RS-15-110

Clinton Power Station, Unit 1
Facility Operating License No. NPF-62
NRC Docket No. 50-461

LaSalle County Station, Units 1 and 2
Facility Operating License Nos. NPF-11 and NPF-18
NRC Docket Nos. 50-373 and 50-374

Subject: Response to Request for Additional Information Regarding Fukushima Lessons
Learned - Flood Hazard Reevaluation Report

Figure 6

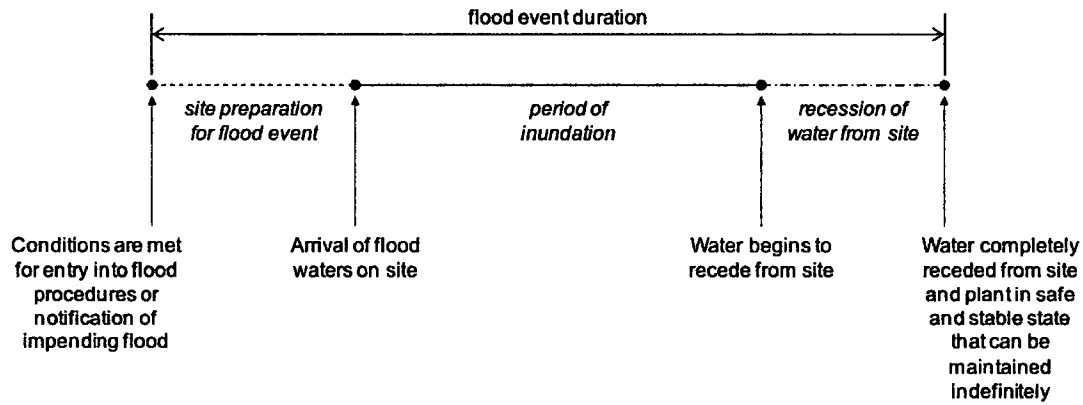
Request: Provide the applicable flood event duration parameters associated with LIP using the results of the flood hazard reevaluation. This includes the warning time the site will have to prepare for the event (e.g., the time between notification of an impending flood event and arrival of floodwaters on site) and the period of time the site is inundated. Provide the basis for the flood event duration, which may include a description of relevant forecasting methods (e.g., products from local, regional, or national weather forecasting centers) and timing information derived from the hazard analysis.

The flood duration parameters in Figure 6 (below) of the NRC Interim Staff Guidance document JLD-ISG-2012-05, "Guidance for Performing an Integrated Assessment," dated November 2012, relevant to LIP are period of inundation, warning time (site preparation time), and recession time. The requested information for period of inundation at critical locations is provided in Reference 1 with additional details provided via flood-depth hydrograph plots in Attachment 3.1 below. The plots in Attachment 3.1, excerpted from Reference 2, also provide recession time information. Warning time for LIP, including forecasting methods, will be addressed during the Integrated Assessment phase of the NTTF Recommendation 2.1 information request response, and depend upon the long-term strategy for the reevaluated LIP flood.
